2 CHARACTERISTICS OF PROPOSALS

3 QUALITY AUDIT CONTEXT

4 ITEMS RAISED

4.1.1 Problem (PC1) – Proposed Toucan Crossings

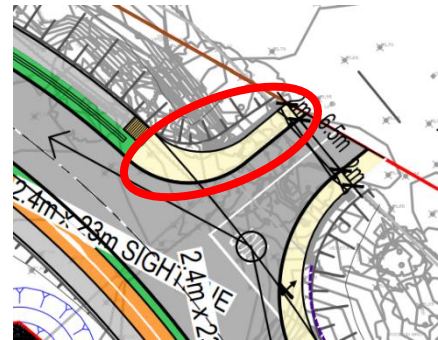
The proposed Toucan crossings do not show vehicular stop lines. Failure to provide appropriate road markings could result in vehicles failing to stop at the crossing resulting in vehicle / pedestrian / cyclist conflicts.

At detailed design stage ensure appropriate road markings are provided in line with the Traffic Signs Manual / Cycle Design Manual.

4.1.3 Problem (PC3) – Priority at Greenway Junction

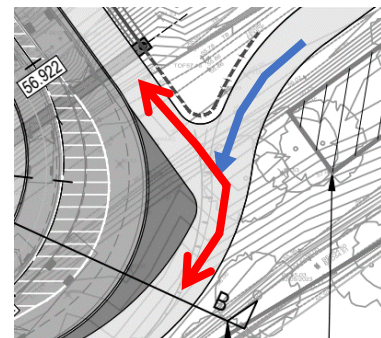
At the tie-in to the existing Greenway, there is no indication as to which direction of travel has priority. Should cyclists be travelling at speed along the Greenway, they could continue into the path of cyclists / pedestrians travelling to / from Quarry Walk leading to potential collisions.
